**MIAMI-DADE COUNTY DEPARTMENT OF PUBLIC WORKS
AND WASTE MANAGEMENT**

**MUNISPORT SITE
COMPREHENSIVE LANDFILL CLOSURE PLAN
AMENDED FORMALIZATION REPORT
FOR THE GROUNDWATER REMEDIATION
AMENDMENT 5**

PERA PHASED APPROACH

April 26, 2012

Figure 1

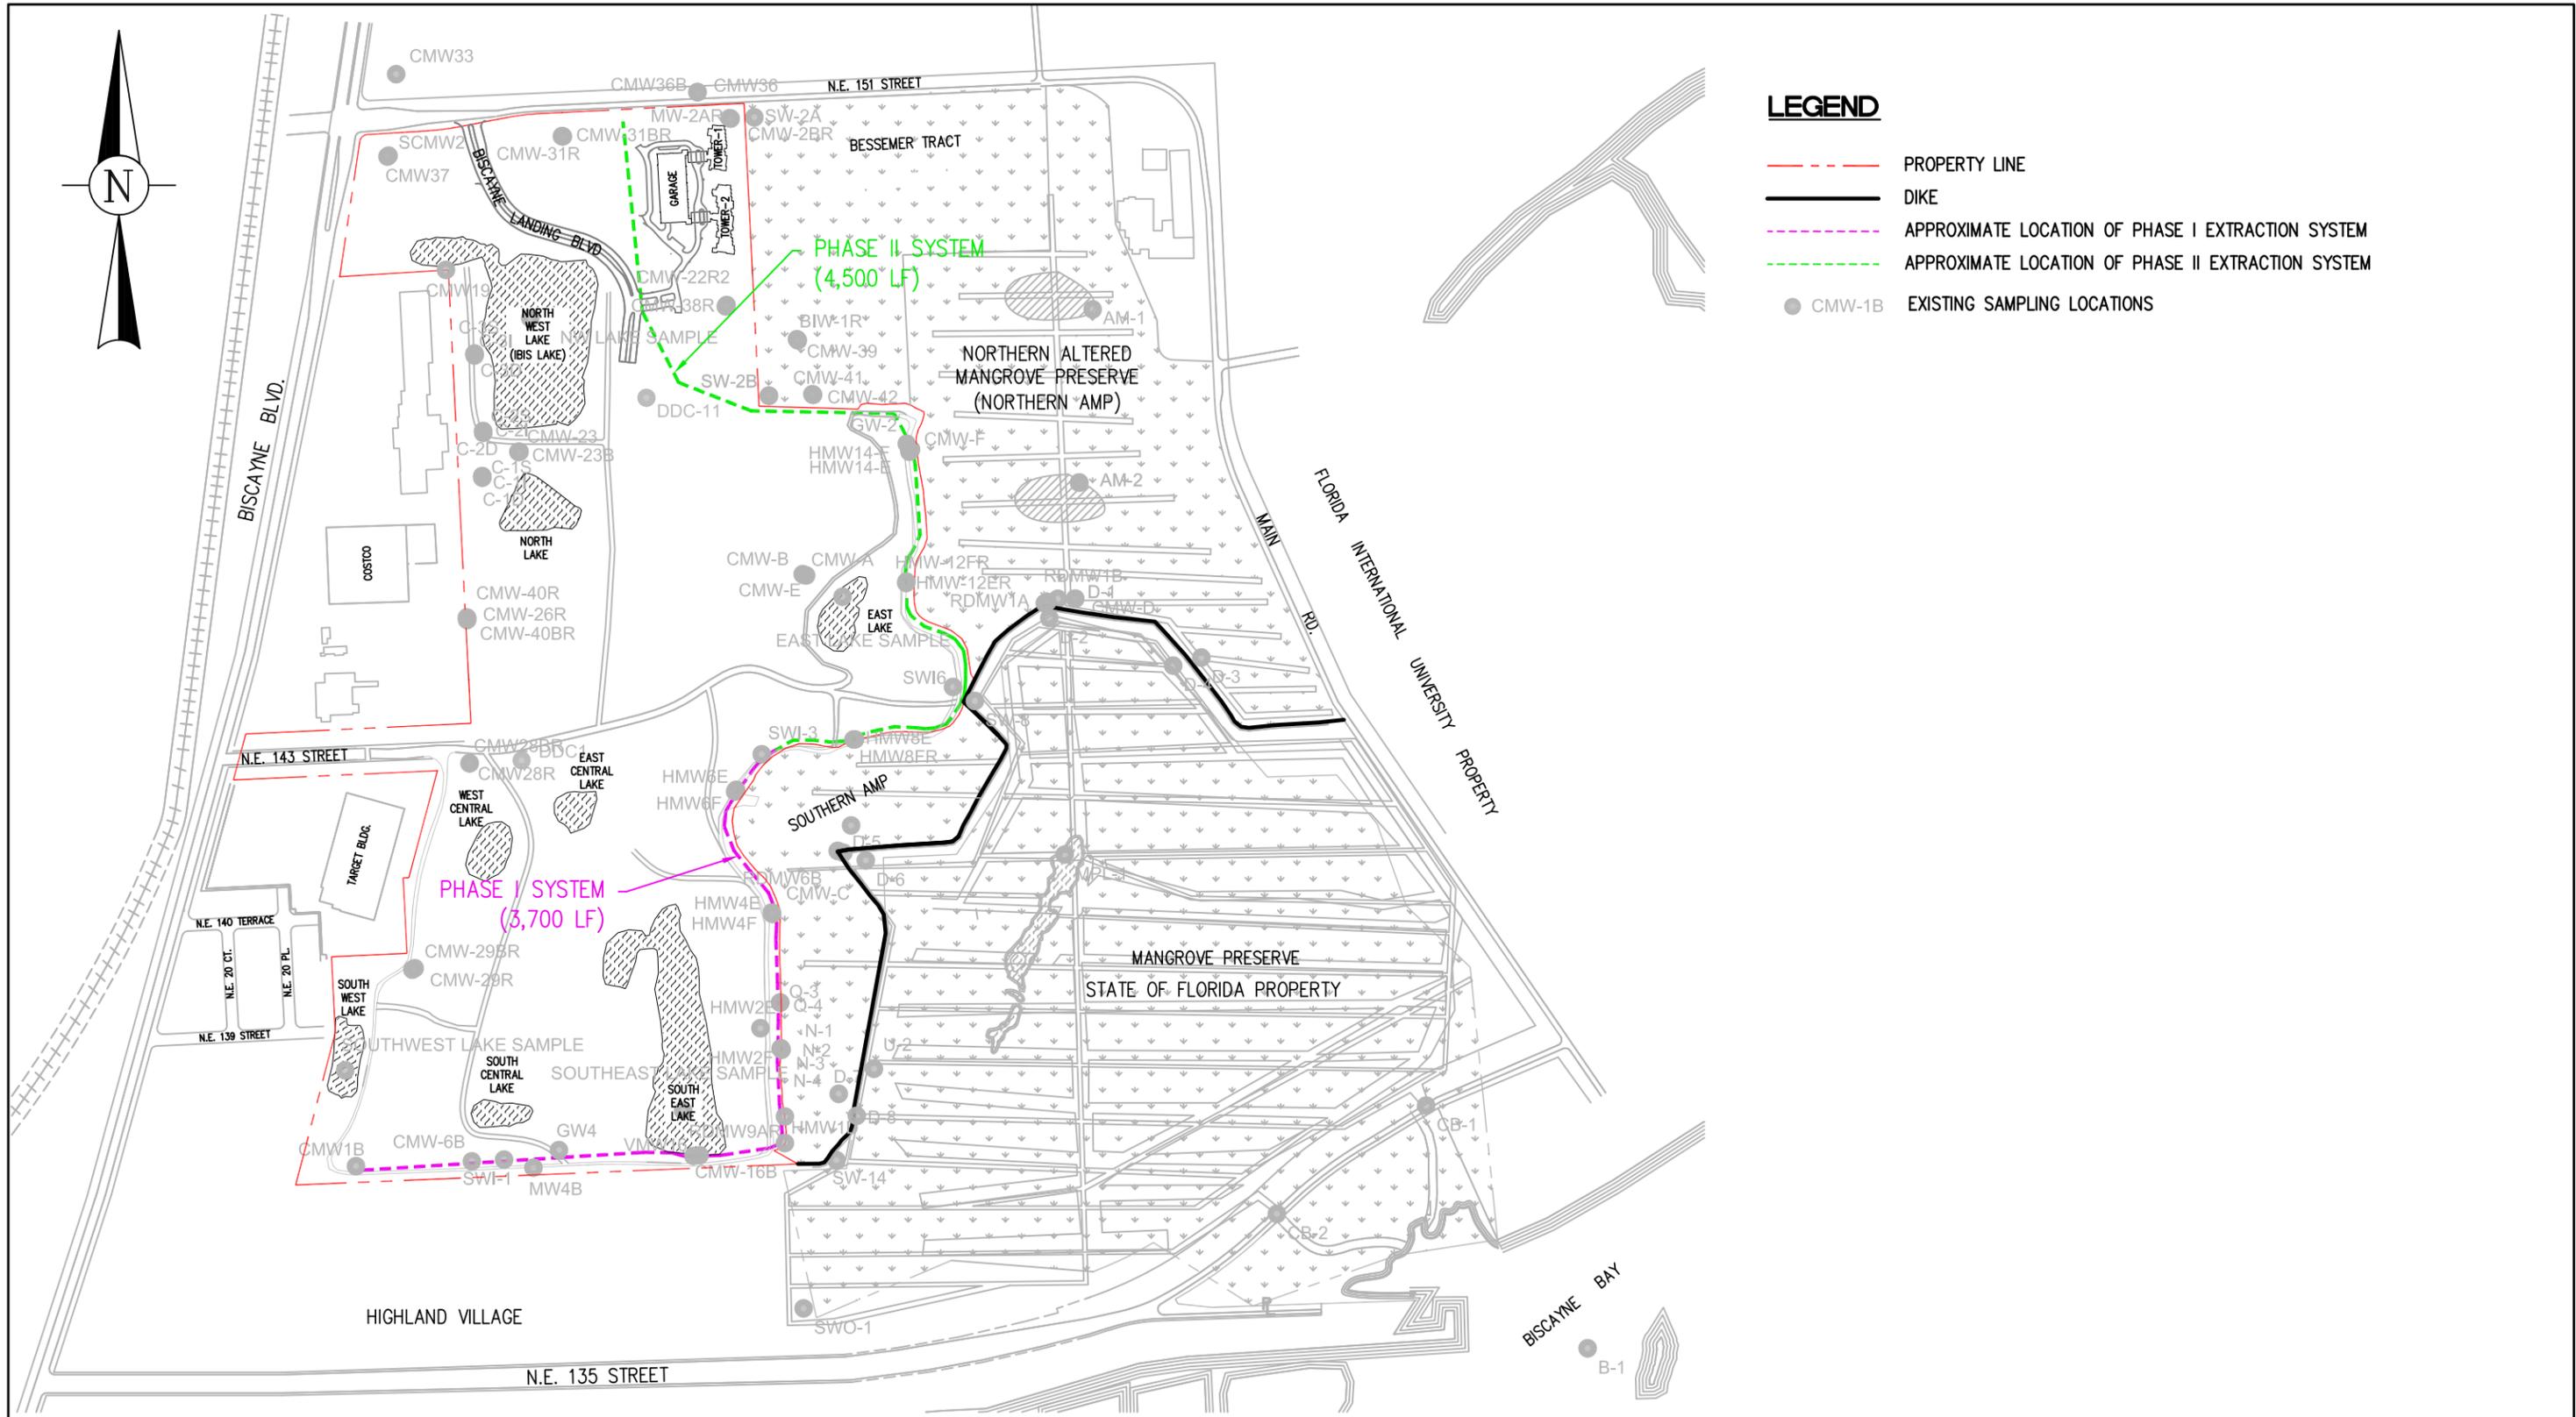
- Because the Phase 2 system is adjacent to the freshwater wetlands (northern altered mangrove preserve (AMP)), PERA has suggested that the Phase 2 system may move westward instead of along the eastern property boundary to avoid potential impacts on the northern AMP (see Figure 1).

We anticipate that Phase 2 of the extraction system will be re-routed to be further west of the adjacent wetlands to minimize any potential impacts (see **Figure 1**). It is therefore anticipated that an additional 200 LF of extraction system will be needed in the final full-scale system. Also, a temporary piping system is needed to convey the extracted groundwater from the termination of the Phase 1 system to the pump station. Lastly, due to the increase in the construction schedule, we have included escalation on the cost of the Phase 2 portion of the extraction system.
